Lake Merritt Station Area Plan

Final Environmental Impact Report

July 2014

Prepared for the **City of Oakland** by

Figure 2.4-5
Proposed Height Limits

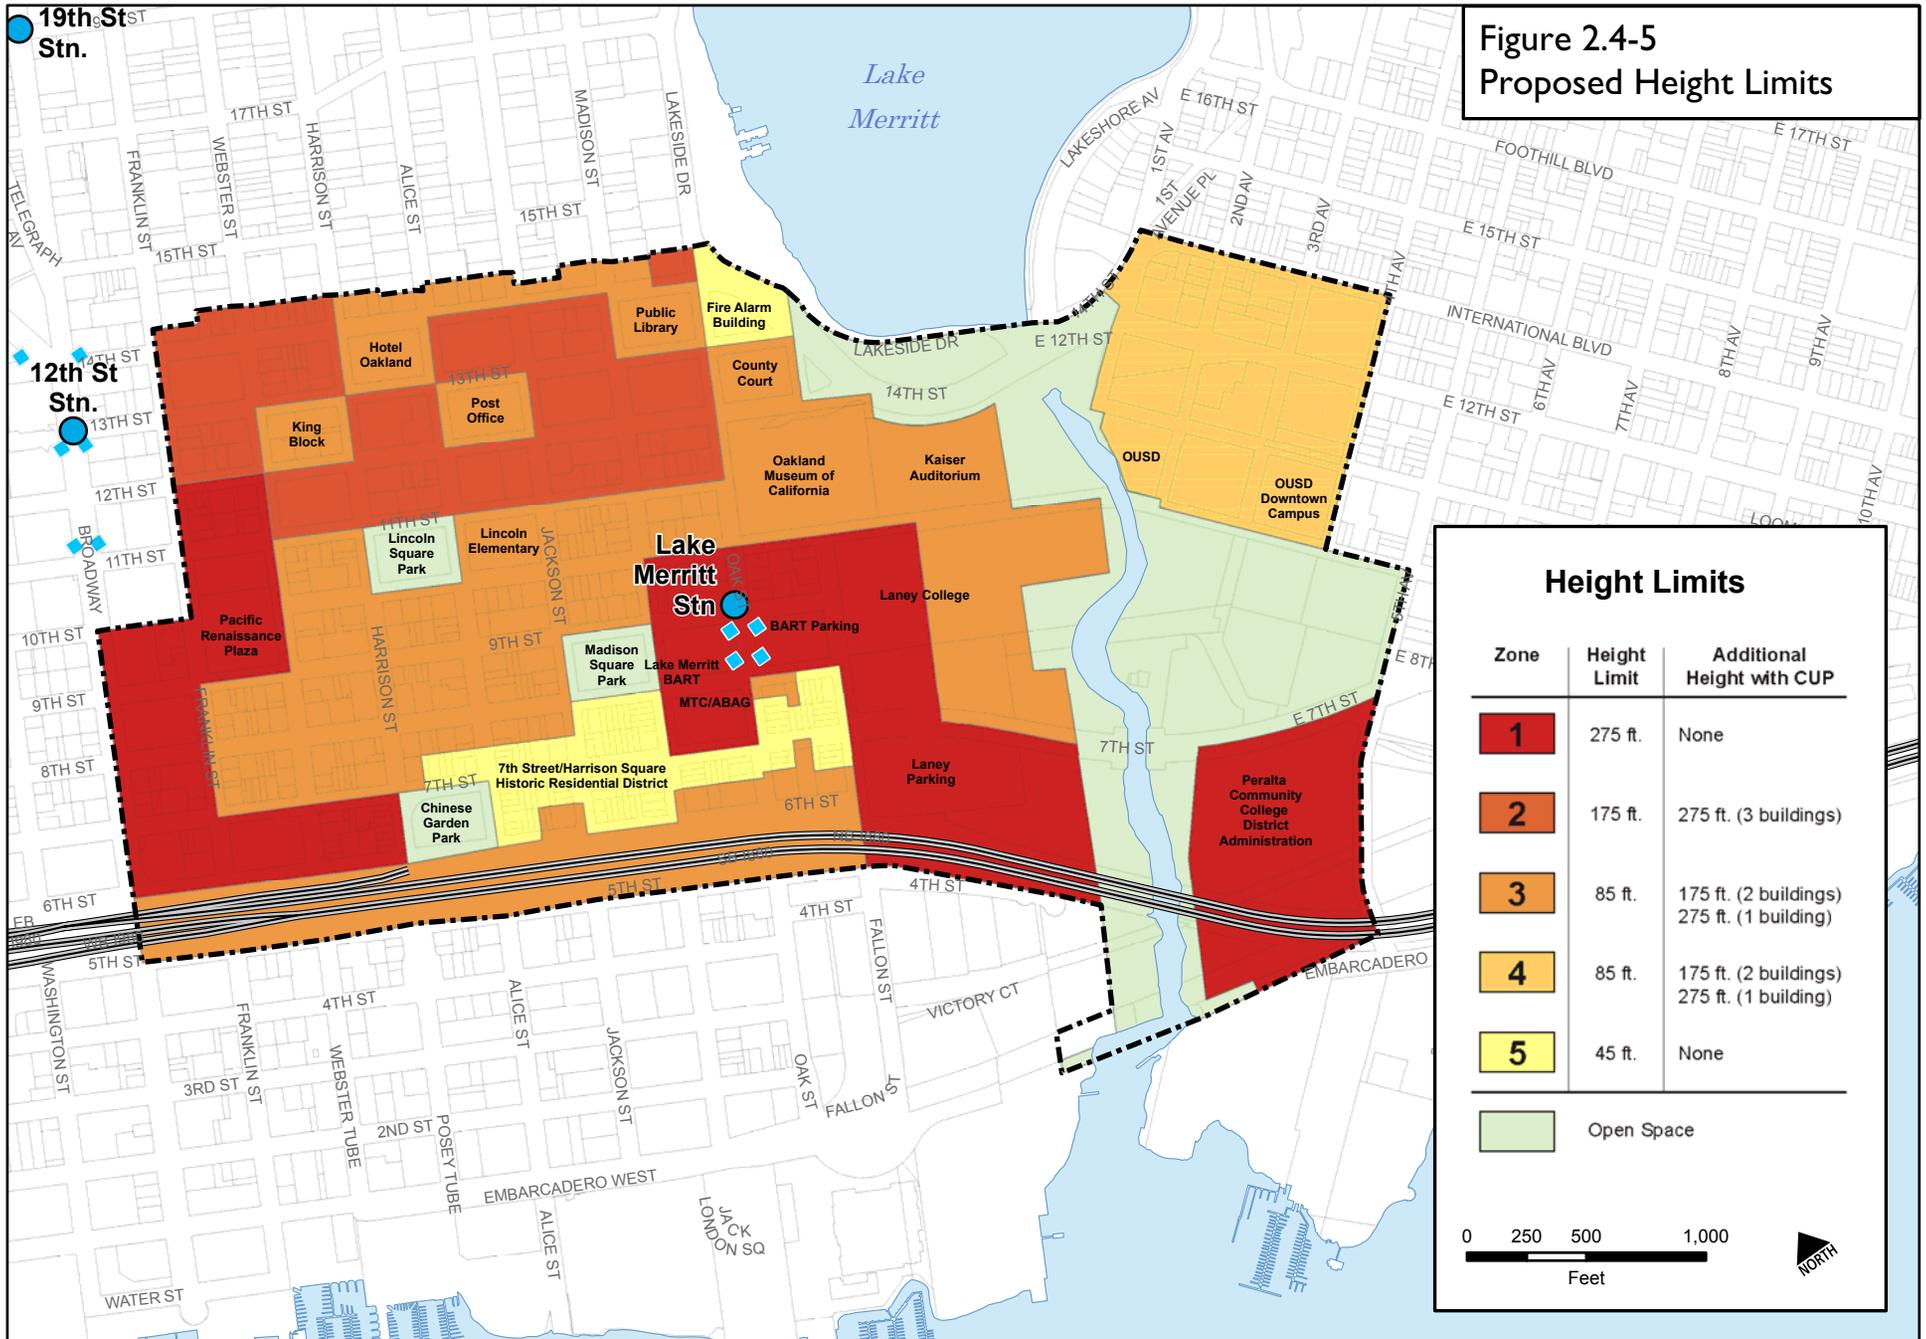
- Figure 2.4-4: Existing Height Limits is revised to clarify opportunity sites.
- Figure 2.4-5: Proposed Height Limits is revised to reflect zoning changes described in Chapter 2 of this FEIR.

Figure 2.5-1
Opportunity Sites
(Sites Most Likely to Redevelop)

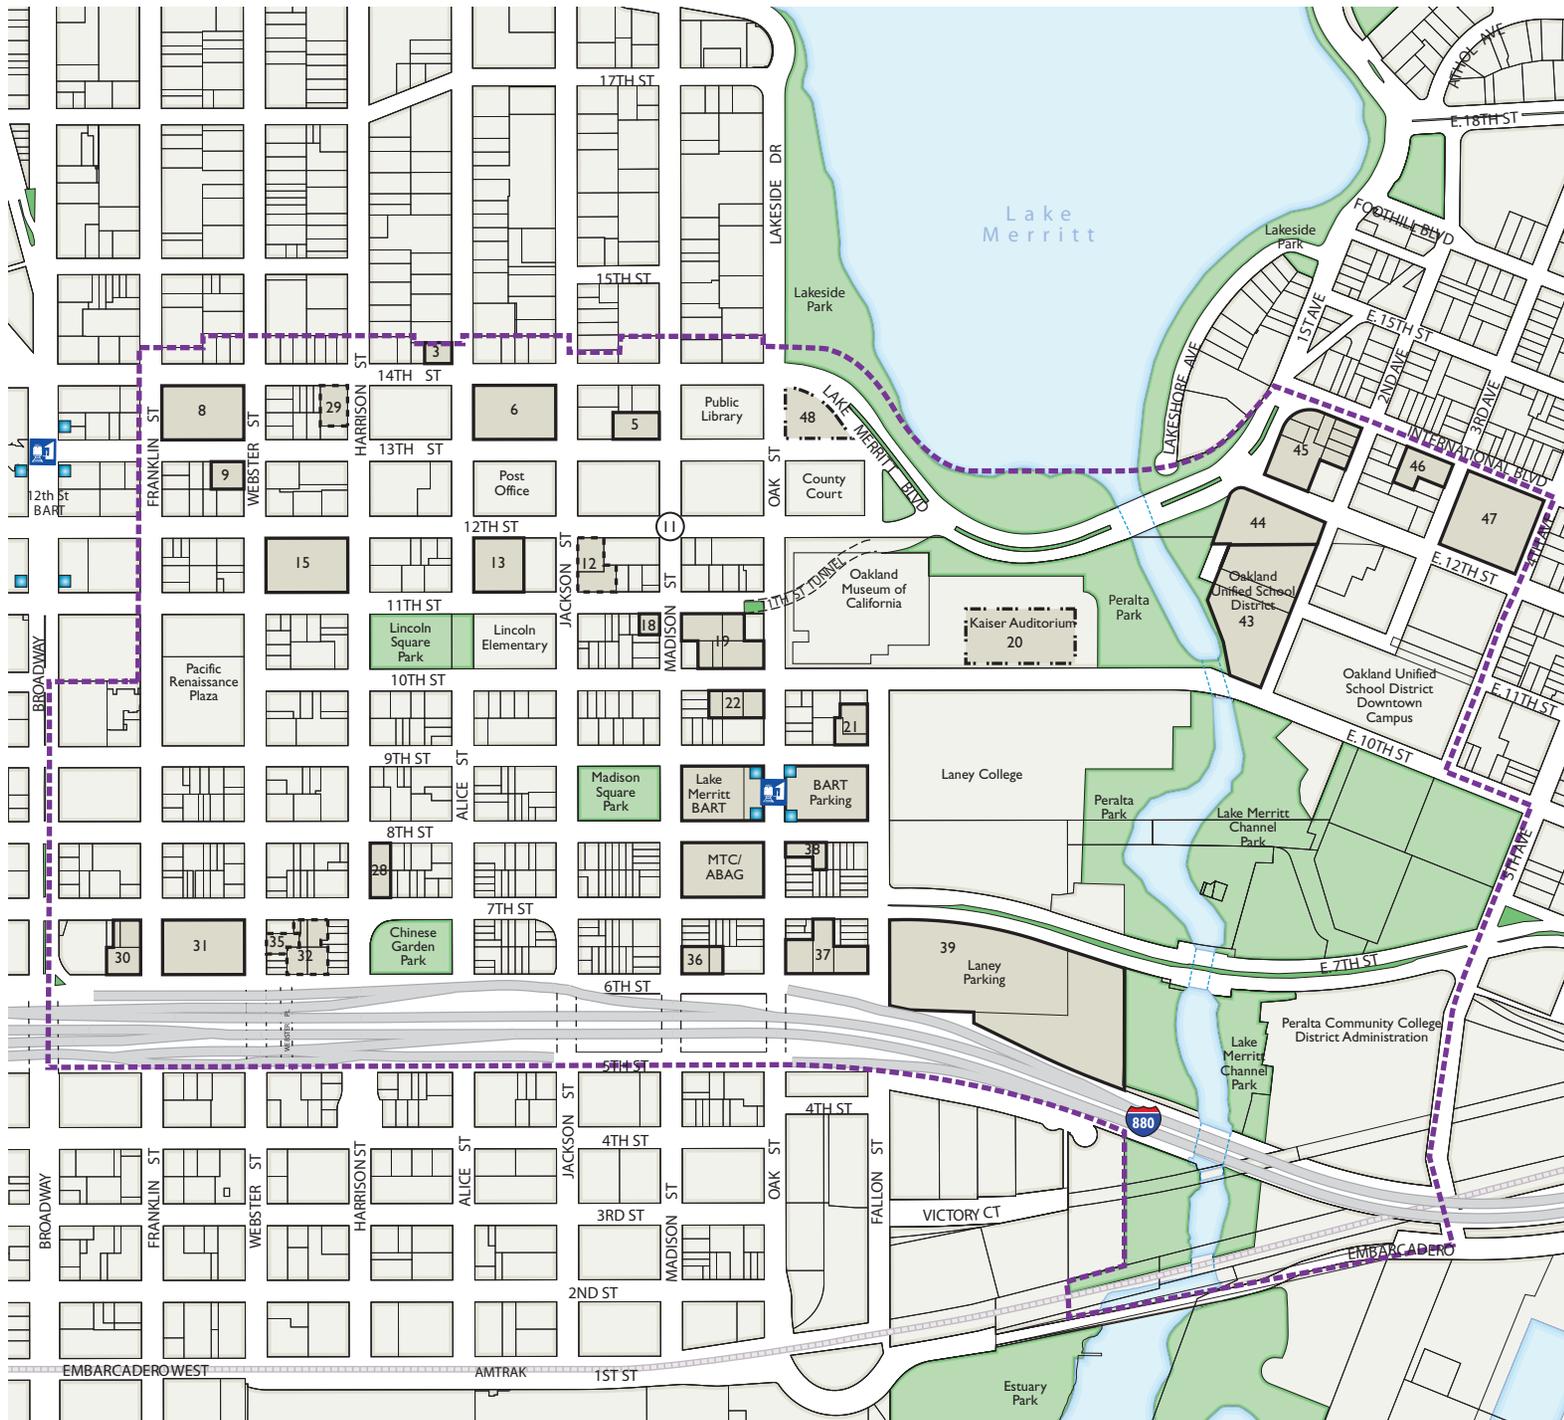
- Figure 2.5-1 Opportunity Sites (Sites Most Likely to Redevelop) is revised to identify Fire Alarm Building site as Opportunity Site #48; to identify the Fire Alarm Building and Kaiser Auditorium as “Opportunity Sites for Adaptive Reuse”; and to add numbers to the opportunity sites at 630 Webster Street and 1331 Harrison Street.

- A2-1 • Figure 2.5-1, Opportunity Sites (Sites Most Likely to Redevelop), is accurate and should be matched by the other related Figures and references throughout the DEIR.

Figure 3.5-1
Existing Parks and
Future Open Space
Opportunities

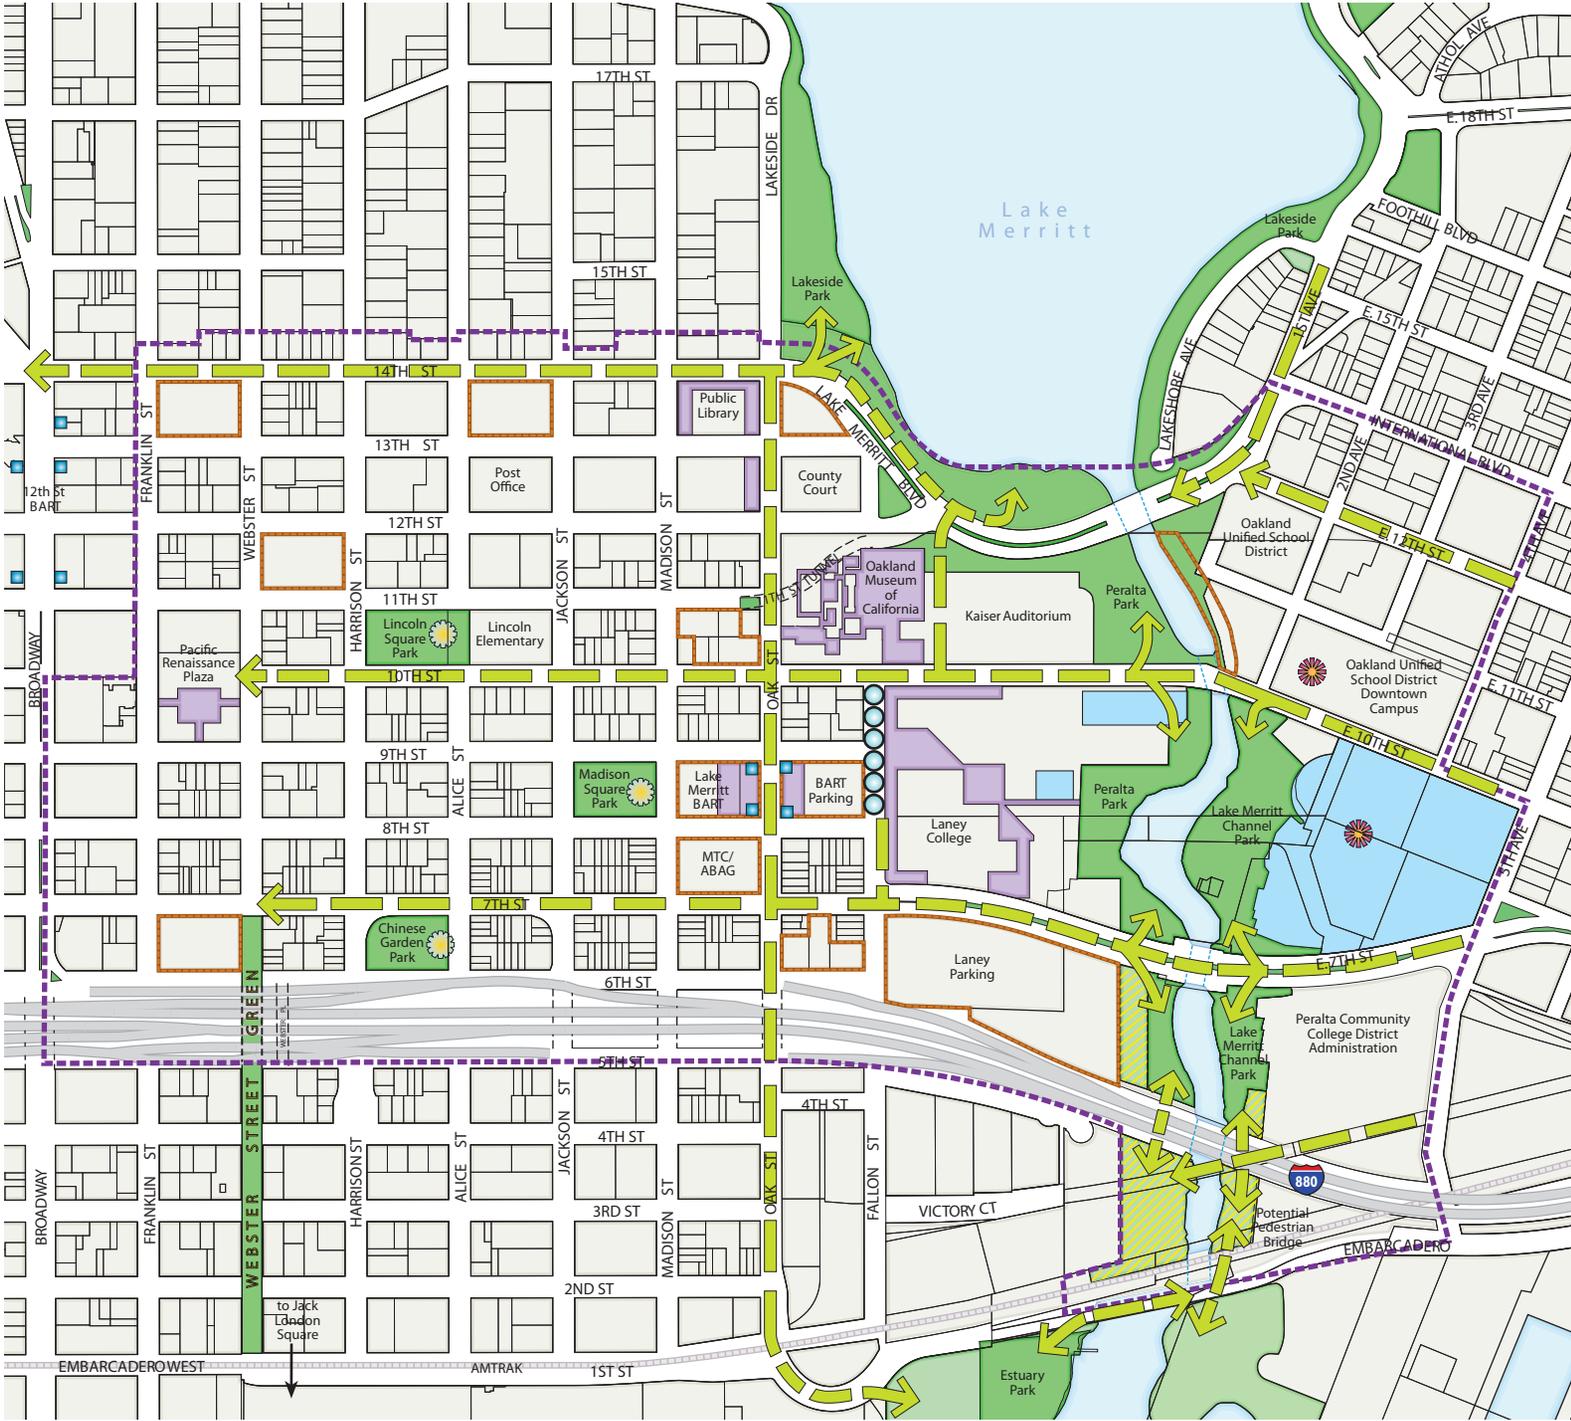
- Figure 3.5-1 Existing Parks and Future Open Space Opportunities revised to clean up formatting by extending the Proposed Open Space district further from the Channel between I-880 and 7th Street and removing park land designation from a portion of Laney College north of 7th Street (where there are existing buildings); removing the Festival Street designation from Alice Street

Fig. 3.8-1
Historic Resources

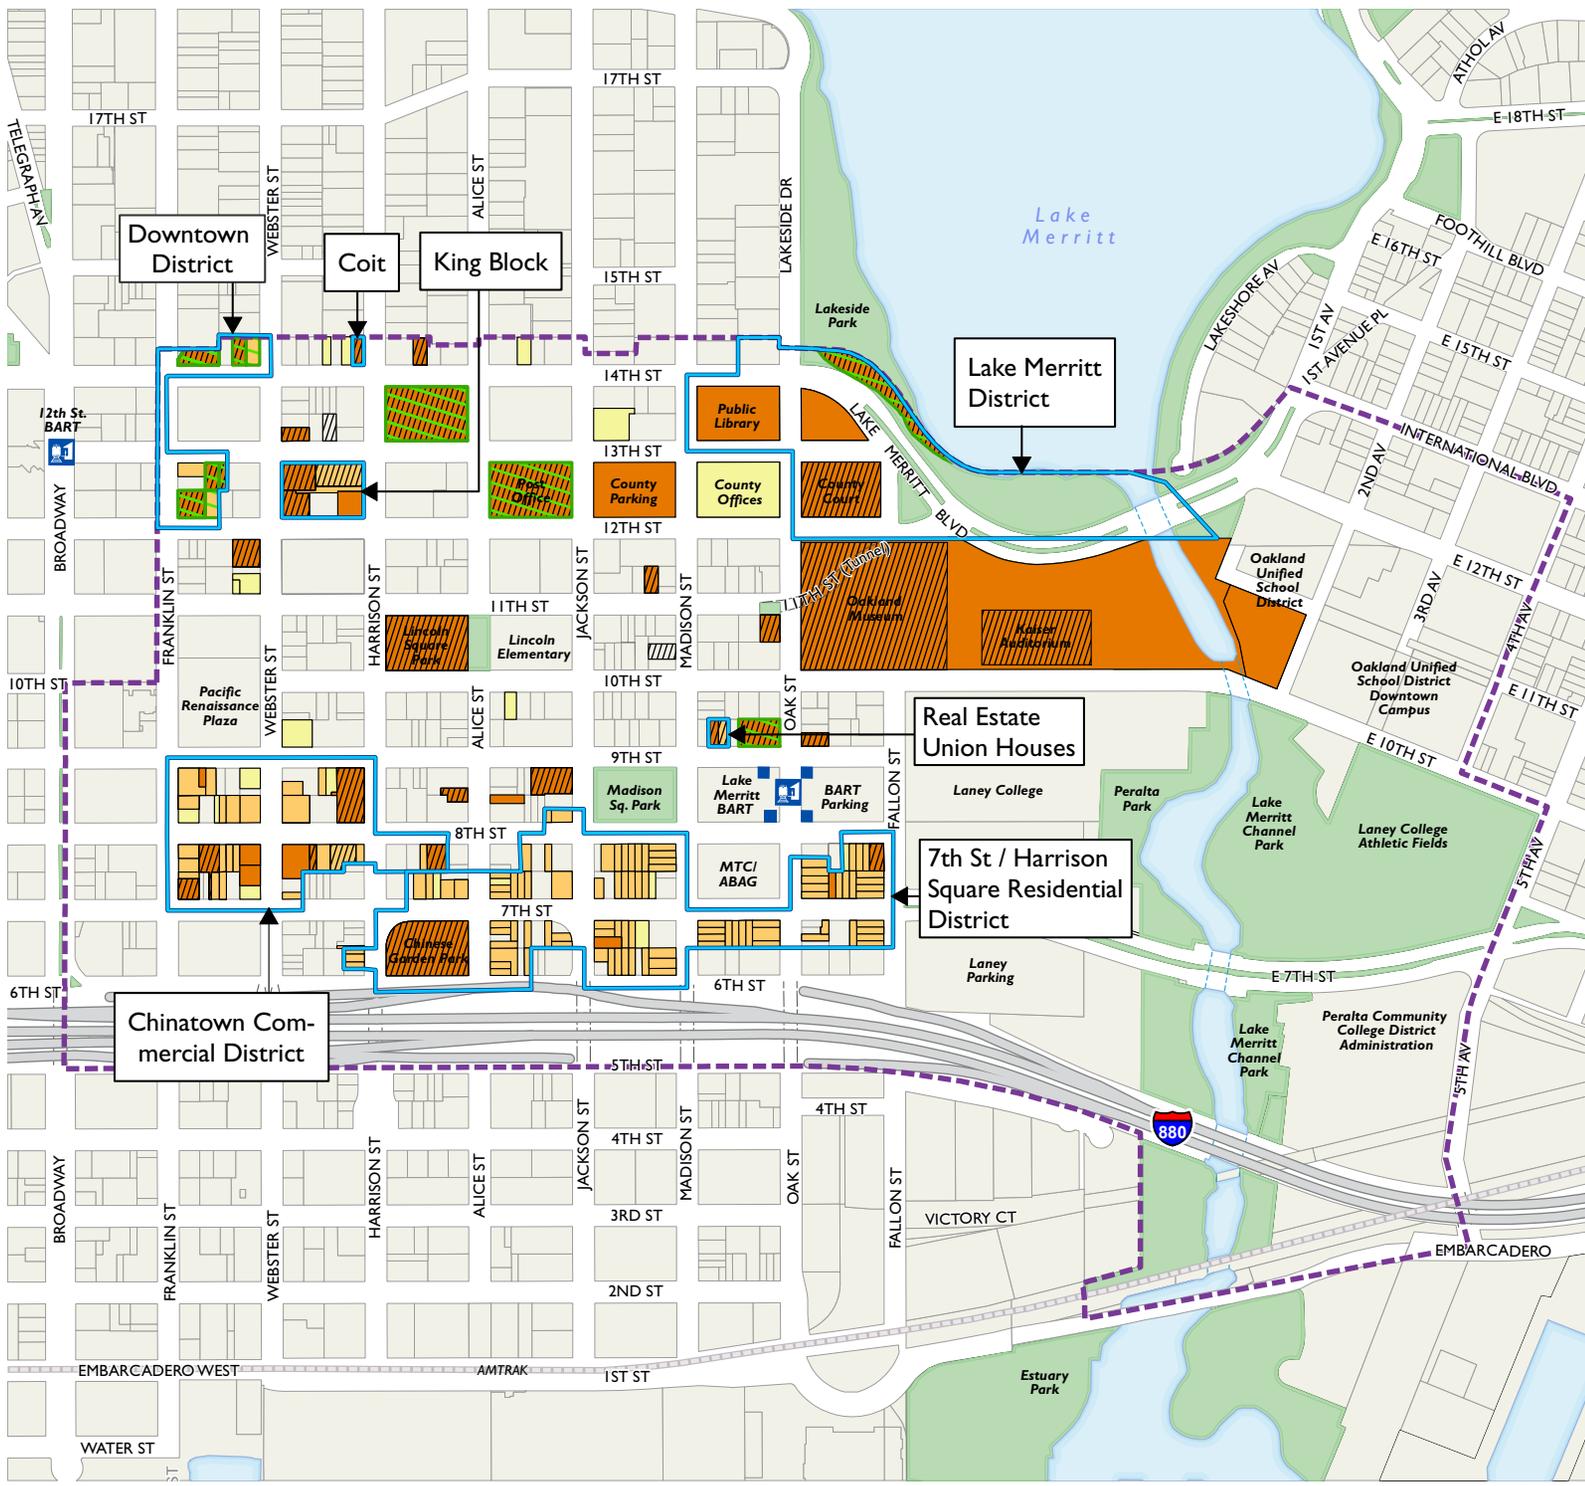
Figure 3.8-1 Historic Resources is revised, using a more distinct symbology for sites listed on the State and/or National Register.

- C1-6: Figure 3.8-1: Historic Resources and Figure 3.8-2: Historic Resources & Opportunity Sites are updated, using a different symbol to denote State and/or National Register-listed properties.
